Central Valley Gas Storage LLC
3333 Warrenville Road
Suite 300
Lisle, IL 60532

June 24, 2016

Regarding: General Order 112 Gas Inspection of Central Valley Gas Storage
(GI-2016-01-CVS-01B & 06) Letter issued May 27, 2016

Emergency Valve Diagram

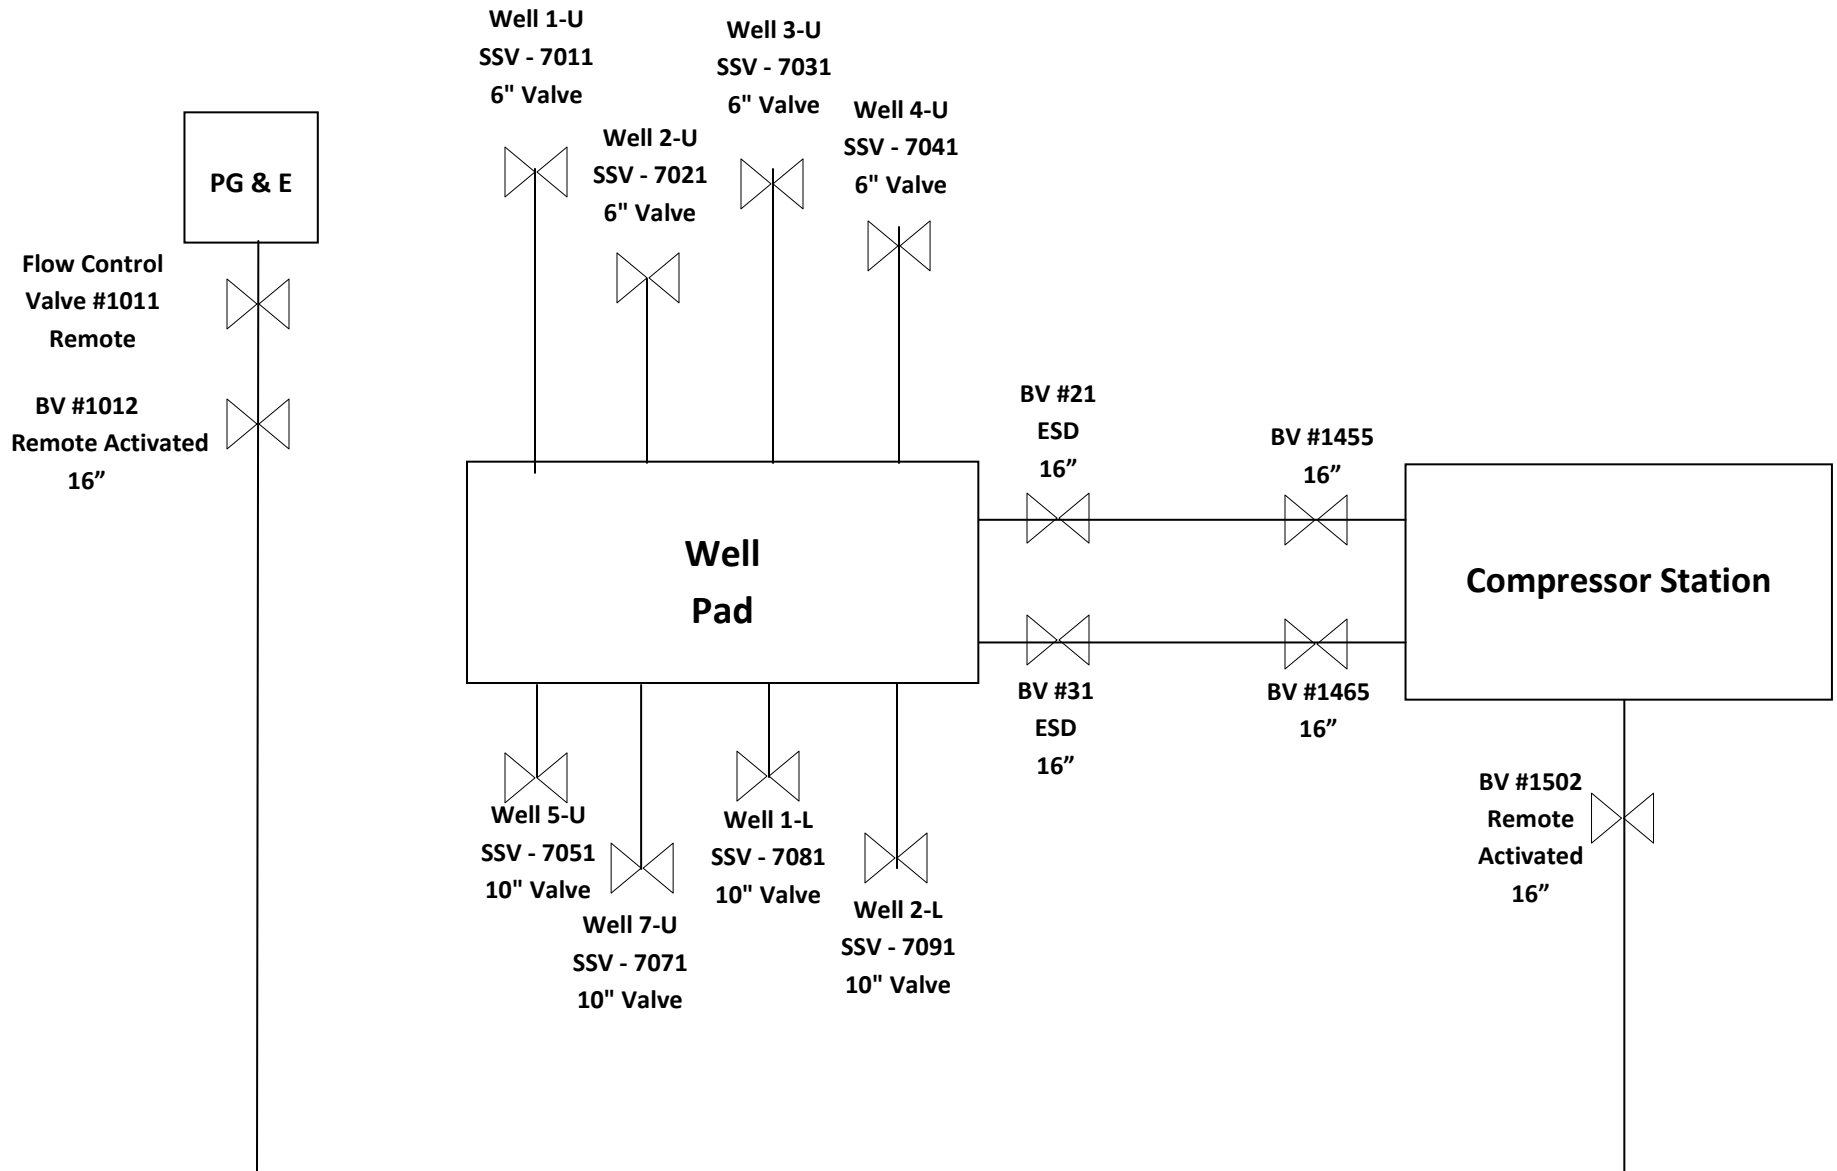
As part of the review of CVGS's Flow Control Valve (FCV) records, SED noted that CVGS did not inspect and partially operate Flow Control Valves (FCV) 0082, FCV 0092, and PIT 1012 once a year.

During the close out meeting, CVGS provided a copy of 2015 inspection record of PIT 1012. However, SED did not find any other records for FCVs 0082, 0092, and PIT 1012 inspections conducted since the beginning of the operation in 2012.

SED determined that CVGS must conduct inspection and testing of FCV devices 0082, 0092, and PIT 1012 once a year not exceeding 15 months as required by §§ 192.739 (a) and 192.745 (a).

To satisfy the requirements of §192.745 (a), the Company had designated other valves to be used during an emergency. See Exhibit 3, titled CVGS Emergency Valve Diagram, which shows the name and location of the emergency valves. Additionally, on December 27, 2012, CVGS first submitted to the CPUC a Valve Location Plan consistent with the requirements of California Public Utilities Code §957. The current version of the CVGS Valve Location Plan is included as Exhibit 4. Both exhibits clearly identify the emergency valves subject to the annual inspection requirements of §192.745 (a).
